**PLANNING AND ZONING COMMISSION ACTION ITEM
STAFF SUMMARY
JULY 1, 2020 PLANNING AND ZONING COMMISSION MEETING**

**A RESOLUTION RECOMMENDING APPROVAL OF A LEVEL IV
DEVELOPMENT APPLICATION FOR A PUD LANDSCAPE PLAN FOR
THE MULTI-FAMILY PROJECT AT 14 ENSIGN DRIVE.**

14 Ensign PUD Landscape Plan

DILLON TOWNHOMES
14 ENSIGN DRIVE, CORINTHIAN HILL
DILLON, SUMMIT COUNTY, COLORADO
DETAIL SHEETS

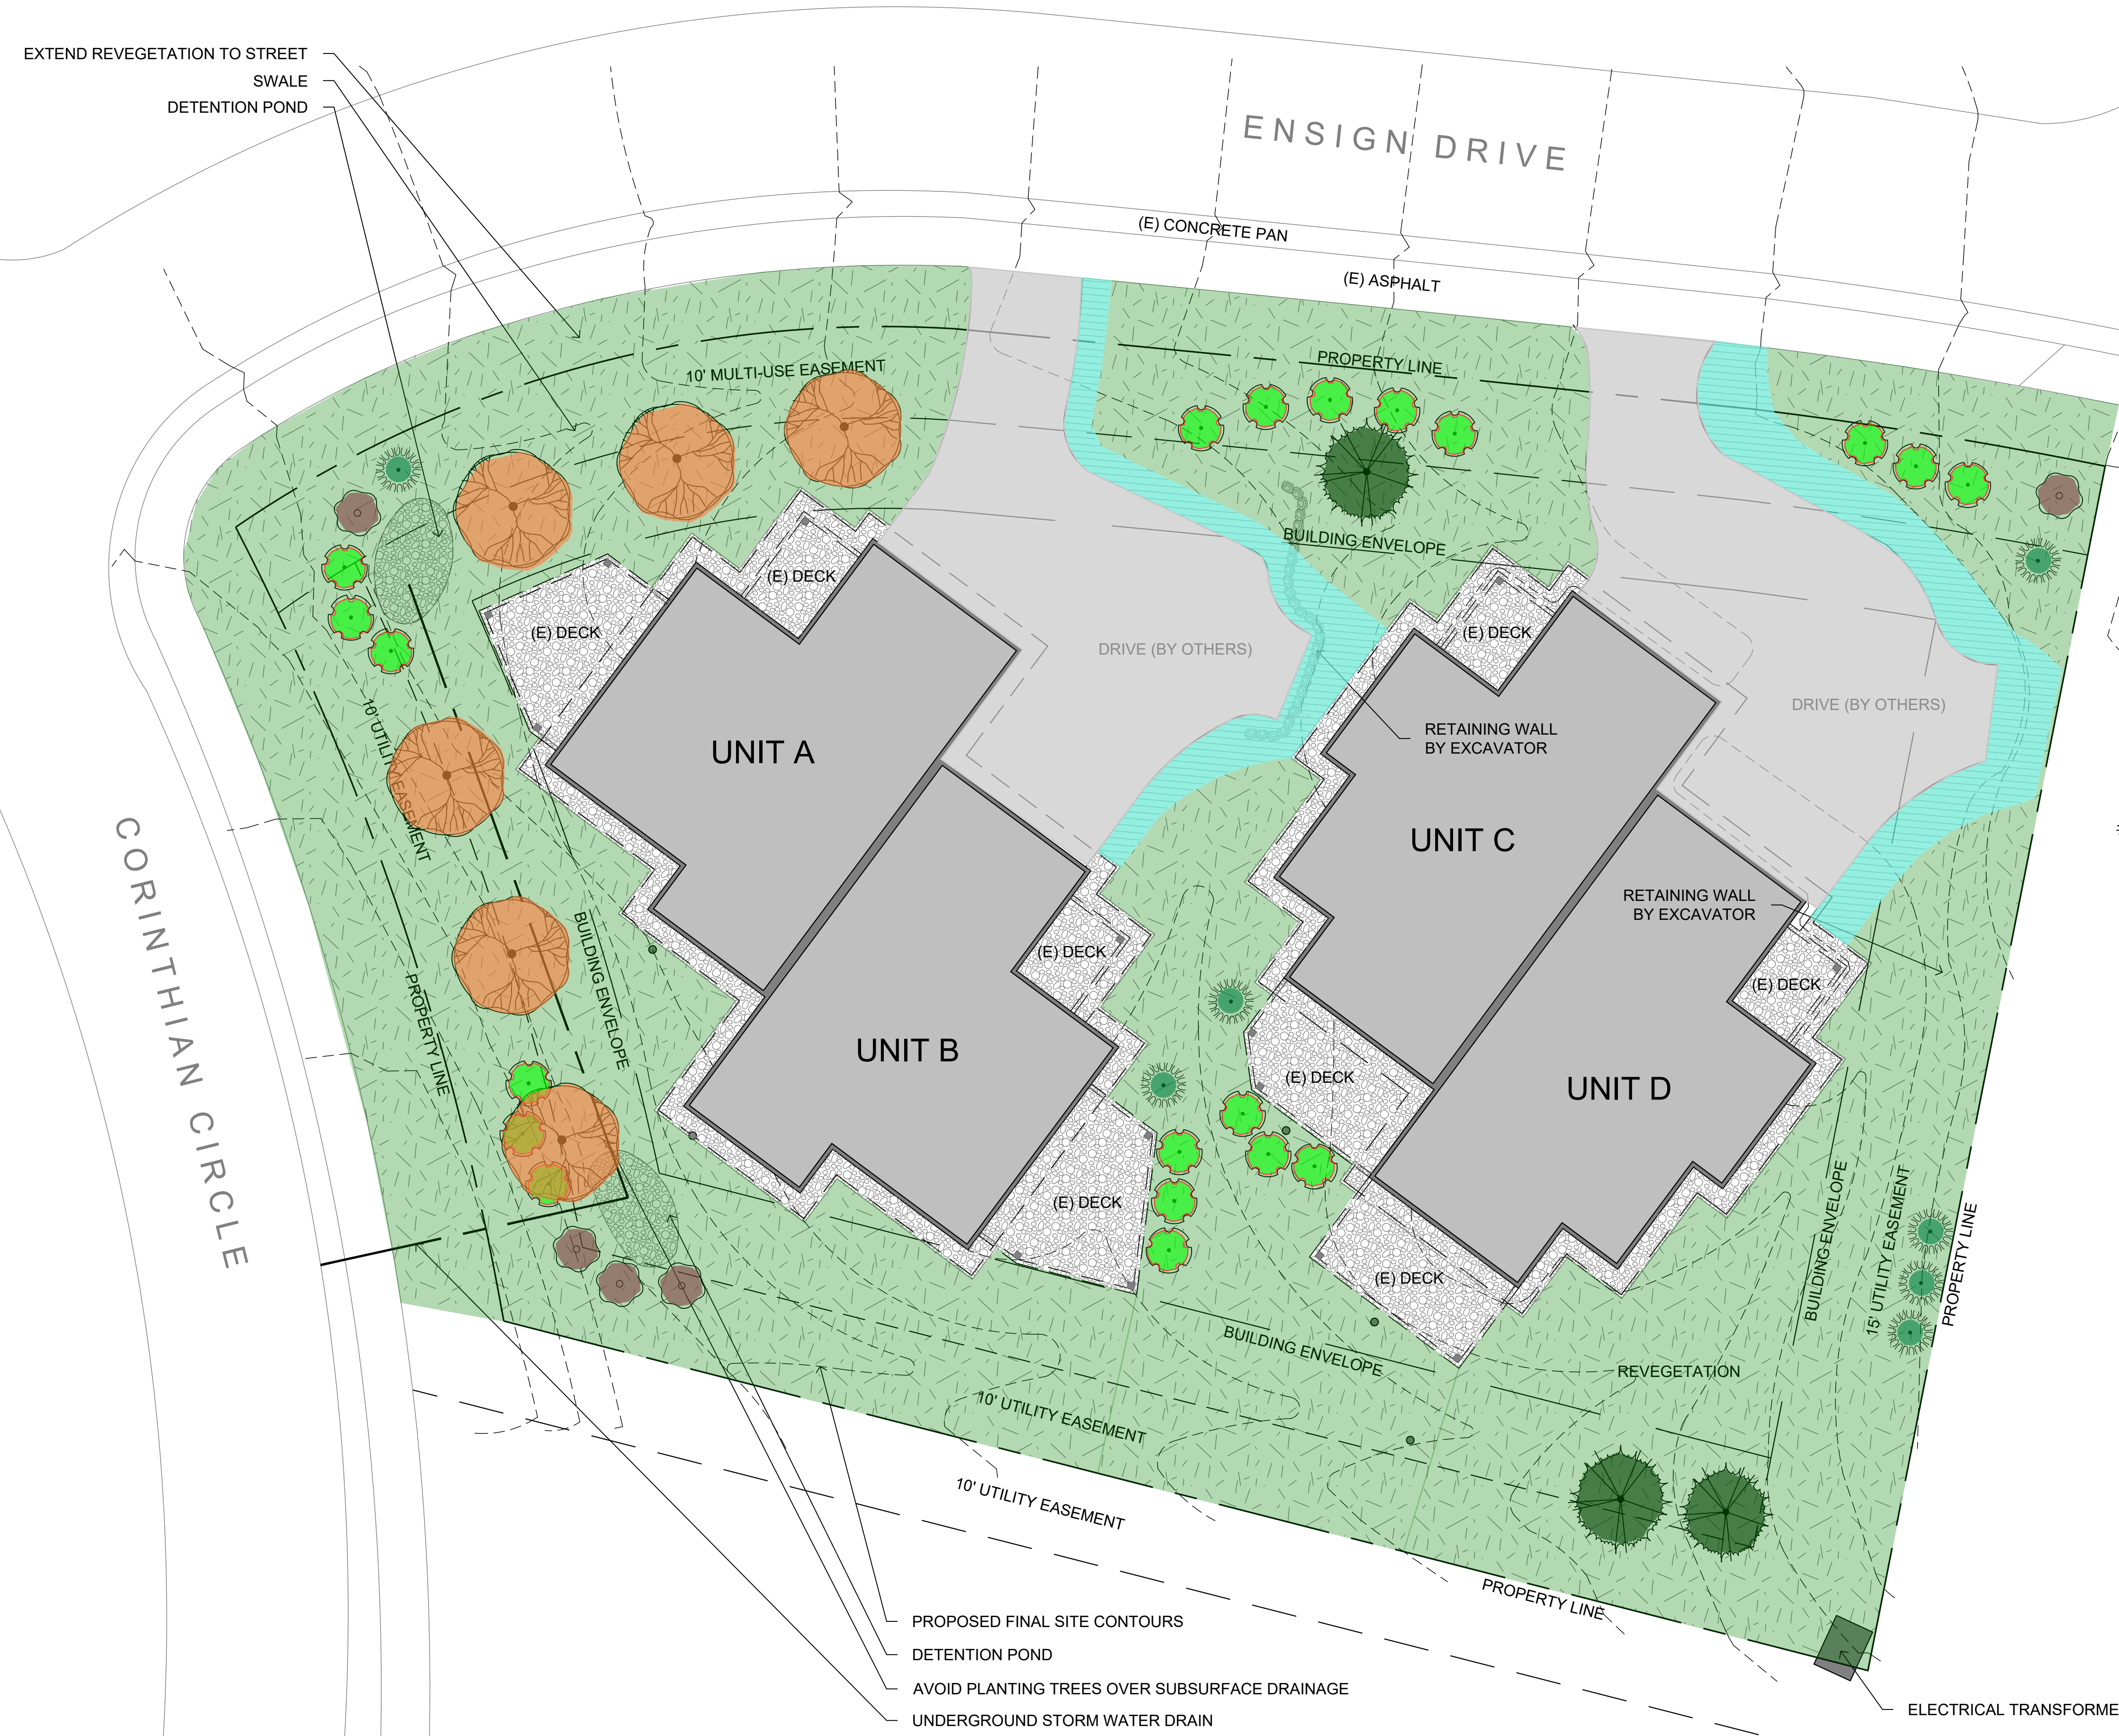
<u>Linear Feet</u>	
Street Frontage	303'-4" +/-	
	<u>Required</u>	<u>Provided</u>
Street Trees at 1 per 15 LF	20	7
Street Shrubs	-	21
Additional Trees	-	2
Additional Shrubs	-	11
TOTAL:	20	41
Required Evergreens	7	3
Required 8' Evergreens	2	2

The application deviates from the general Code requirements by providing fewer evergreens and street trees. This is in response to the Corinthian Hill Property Owner's Association who asked the Applicant to provide a landscape plan that does not impact neighboring views of the lake and mountains by having too many tall growing evergreen trees. The Applicant has proposed Bristlecone Pine trees that are slow growing and do not have an excessive mature height. The other tree species provided is Spring Snow Crabapple which also do not grow very tall. The maximum mature height of a Bristlecone Pine is about 25 feet, and a Spring Snow Crabapple maximum mature height is about 20 feet. In contrast Colorado Spruce and Blue Spruce trees can grow up to 75-115 feet tall. Where the plan may lack in the total number of street trees, it more than makes up for that with the numerous additional shrubs of varying species: Chokecherry, Alpine Current, and Dwarf Artic Willow.

Snow Storage: The Code requires snow storage areas of not less than 25% of the hardscape snow removal area. The site has approximately 2,930 square feet of hardscape requiring snow removal. The PUD Landscape Plan shows a total of 877 square feet of snow storage provided, which is 30% of the hardscape area.

Off-Street Parking: Parking is provided in the garages of the units, as well as surface parking in front of the garages. There are two separate driveway cuts proposed, one for each of the two buildings. The Code requires off-street parking areas to be screened with landscaping. Landscaping is provided in the vicinity of the driveways to screen vehicles.

- E. No trees shall be planted within ten (10) feet laterally of an underground water or sanitary sewer service or main.
